Ref: SSD-88004956
Council Ref: S15383

RE: SUBMISSION TO SSD-88004956

Ku-ring-gai Council's objection to SSD-88004956 at 95-97 Stanhope Road, Killara.

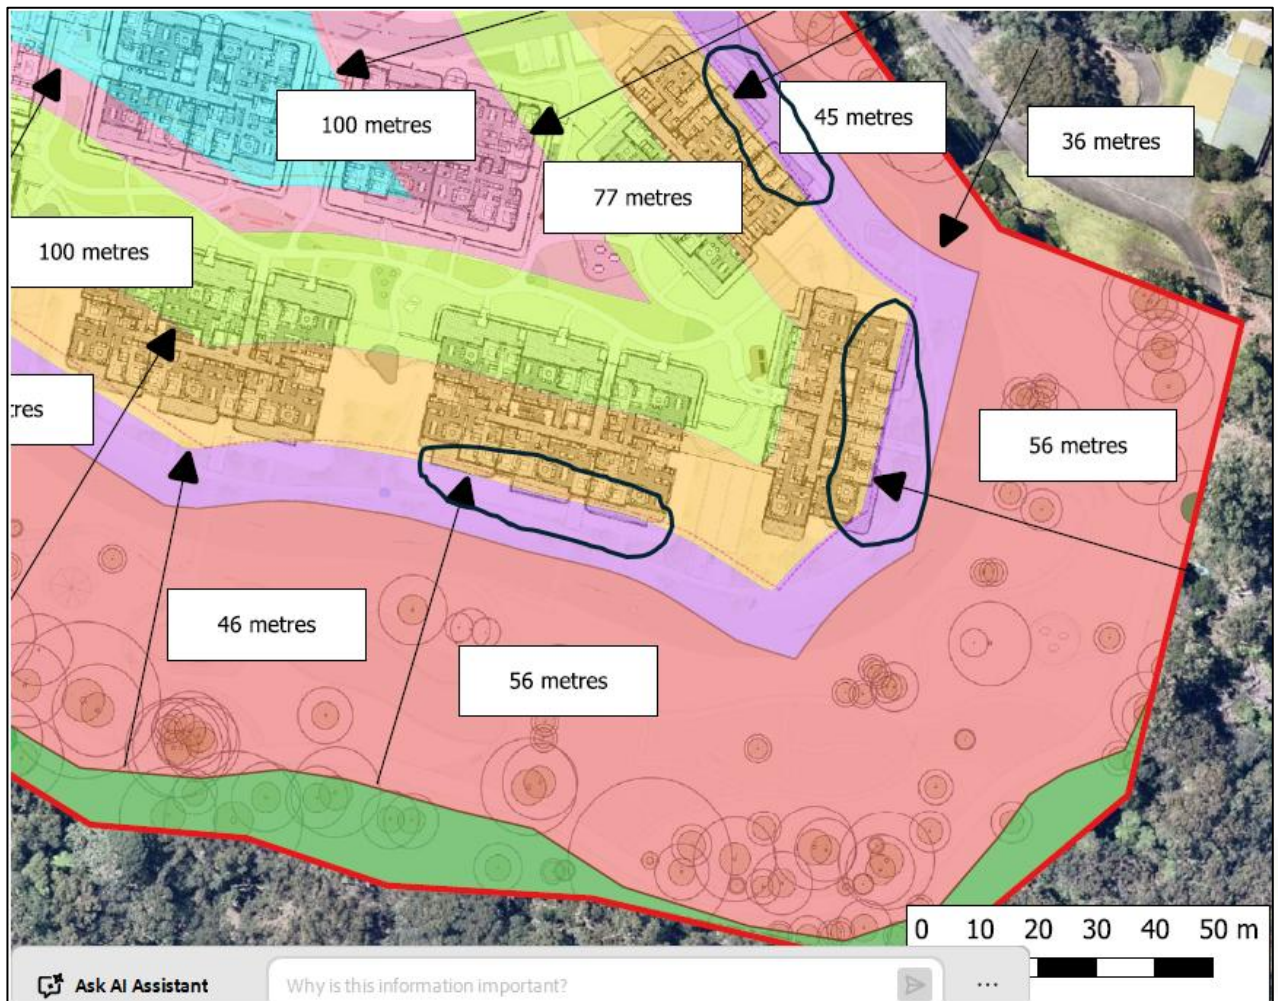
- The Bushfire Assessment Report states at page 15:

“All fire catchments available to the subject site would require a fire burning against the prevailing fire weather for this area.”

In Councils view, this statement is disputed, as the ridge/gully topography, coupled with channeling of strong winds, would readily provide significant fire paths in the vicinity and the slopes below the subject land would even further enhance potential bushfire impacts. The consultant has not provided any atmospheric modelling to support their statement. In 2024 I undertook a Strategic Bushfire Study for the subject site, which demonstrated the potential level of bushfire attack, and intensity, of future wildfire activity.

Figure 8 showing site shaded red and contours

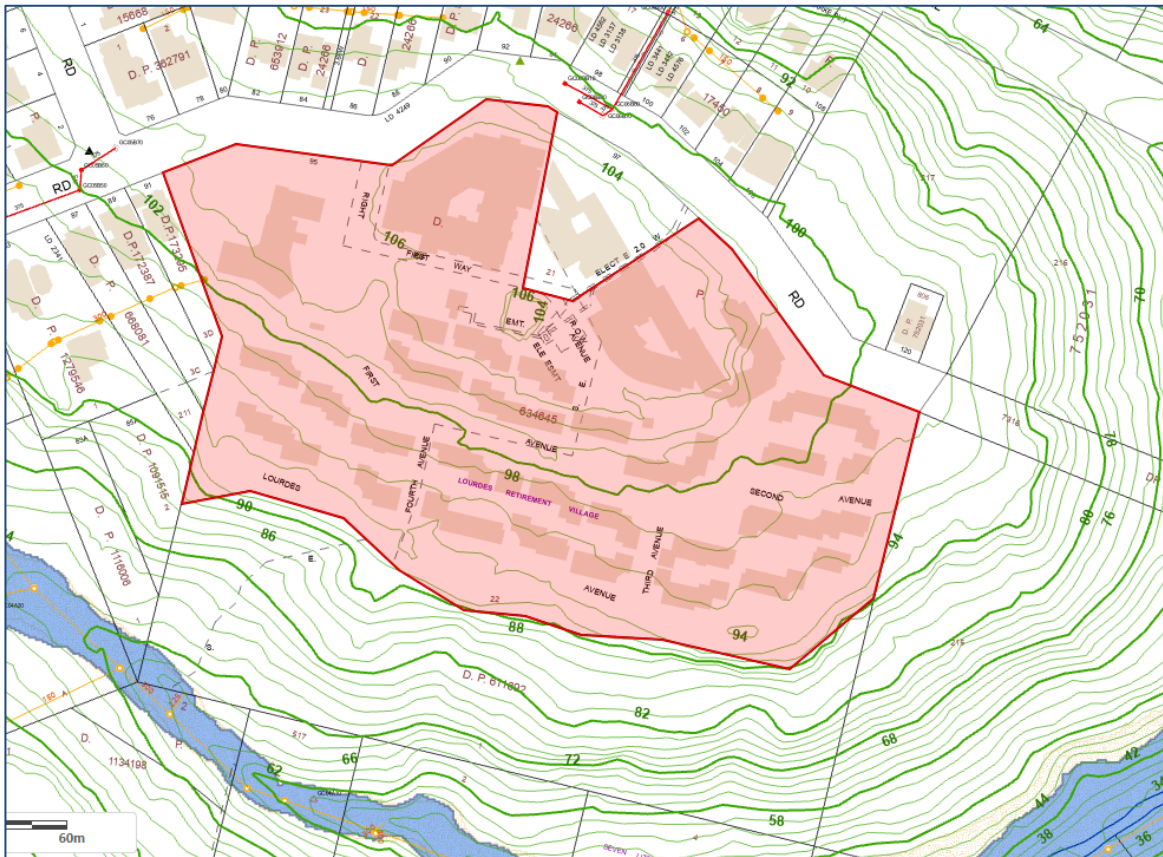
The stormwater management plan proposes to utilize three existing detention basins for the stormwater management of the site. The stormwater report states that *"the design proposed to direct flows to the existing stormwater detention basins to the southern portion of the property and ultimately to Gordon Creek"*. However, the report does not clarify what is the legal point of discharge for this proposal.

The adjacent property to the site is Council's owned land. Council requires that the discharge of stormwater flows from the subject development site must be controlled to Council's public drainage system / watercourse without causing any nuisance and uncontrolled runoff directed to adjoining and downstream properties. Clarification is sought in relation with the existing or proposed point of discharge for the proposed development.

4. Truck access

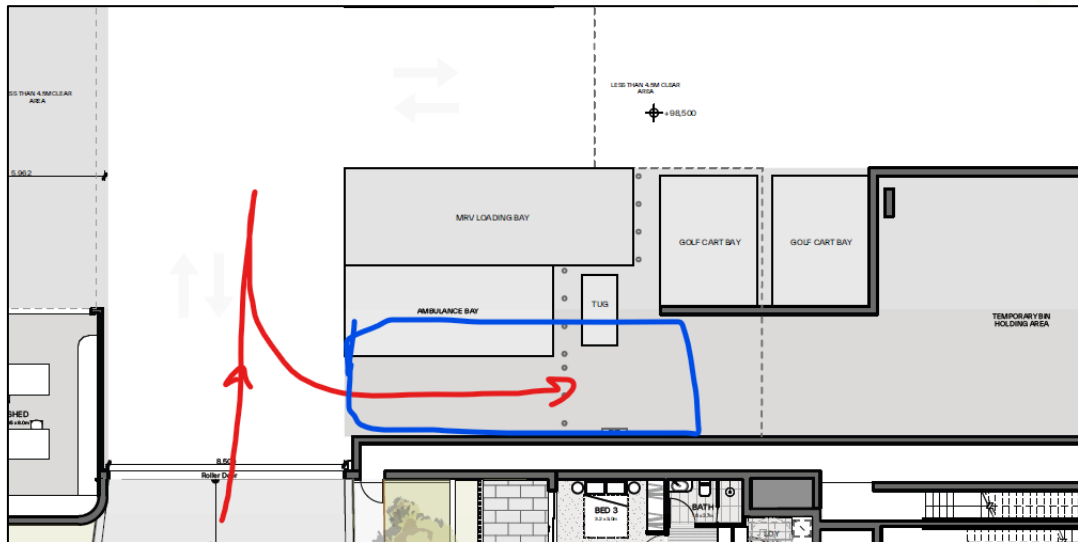
- Loading area to be design for council HRV waste truck as per AS2890.2
- HRV needs to forward in down the drive then reverse into the loading dock then forward out. Only 1 reverse movement is allowed.
- Separate collection area for bulky waste needs to be provided which the HRV truck can access directly.

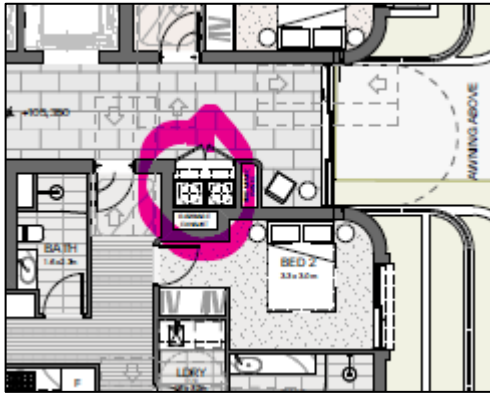
- a. Lack of recycling is provided on each floor
- b. A room on each floor, for the independent living units, is best to store all bins and the chute. A chute facing the hallway is likely to emit smells if the waste is not disposed of properly and chute door left open. This ensures waste and recycling facilities are easily accessible for all residents.
- c. Single chute for waste only – no recycling chute allowed.
- d. Room is to be mechanically ventilated and drain to Sydney water.
- e. Waste room is to be no further than 30m from any unit.
- f. Needs to be sized to fit all bins and chute.

- i. Each floor, of independent living needs a waste cupboard to include a waste chute/ container recycling and paper recycling in addition to a FO bin. – so, the equivalent space for waste chute and 3 bins needs to be provided within the one room.
